EAST ELEVATION PROPOSAL 705 RIVERSIDE ST.
 1/4" = 1'-0" 7/17/01

SECOND FLOOR PLAN PROPOSAL

BUTCH & RALPH / 705 RIVERSIDE ST.
FIRST FLOOR PLAN PROPOSAL
1/4" = 1'-0" 7.17.01

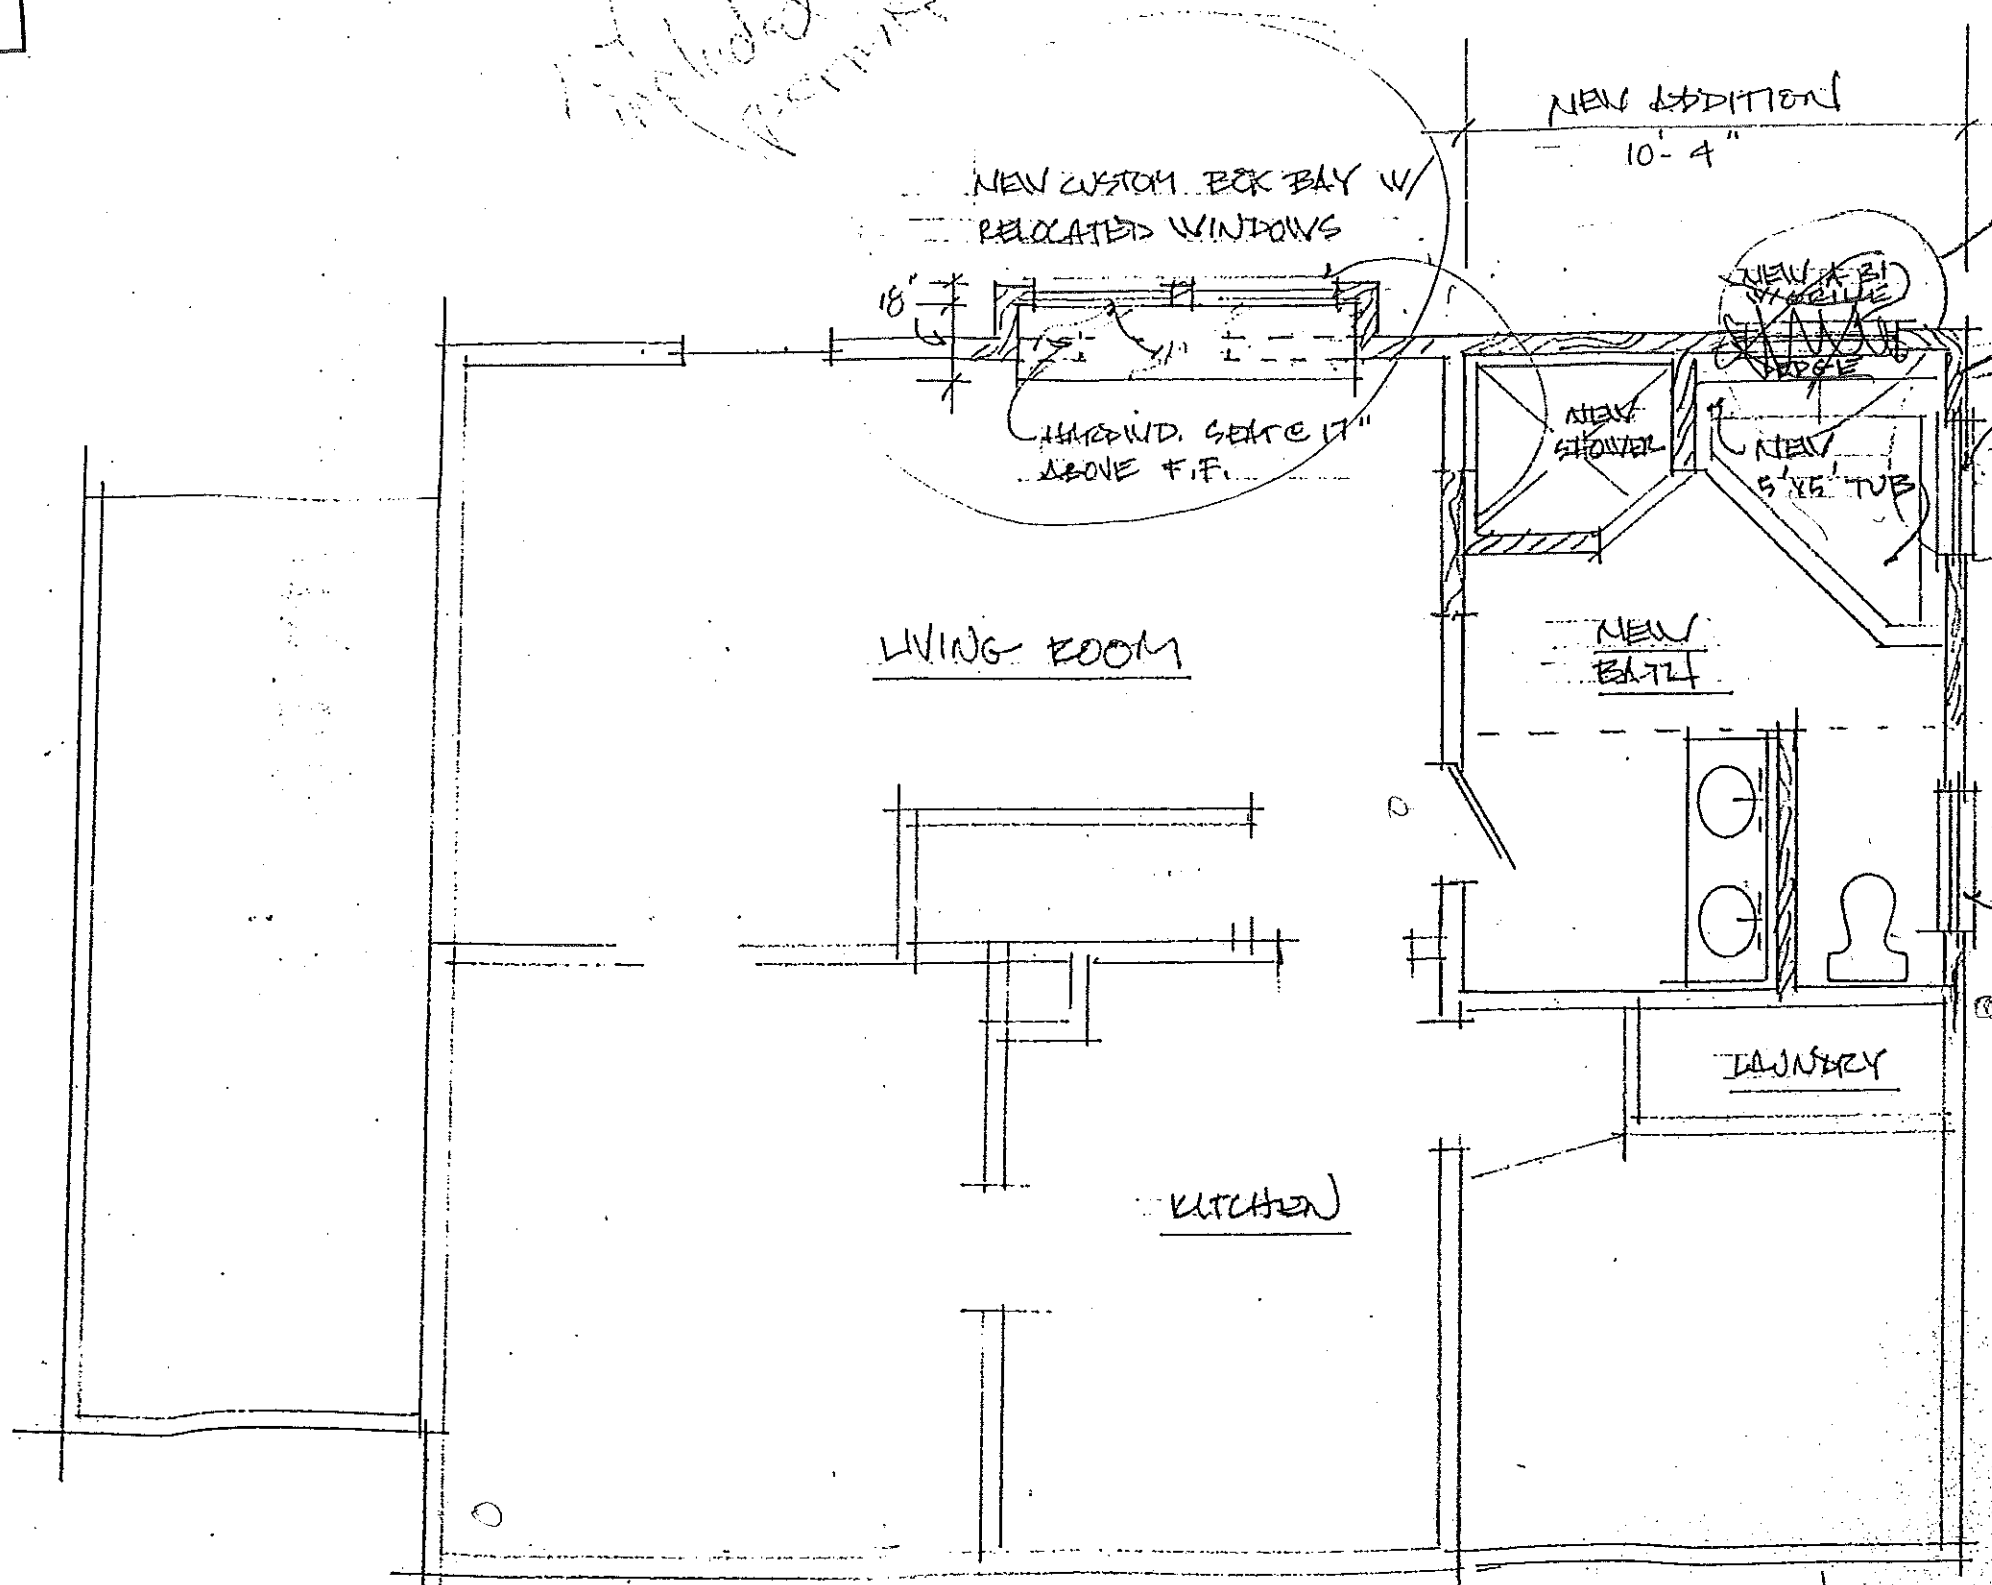
Included Permit

*2x6 Stud
Glazing
1600*

*2x6
1600*

*RETAIN
EXIST. D.H.*

*Foundation...
Footing 8x16
8" Block Wall
4" Slabs Fiber Reinforced
Pinned to Existing Footing
Drainage Connected*
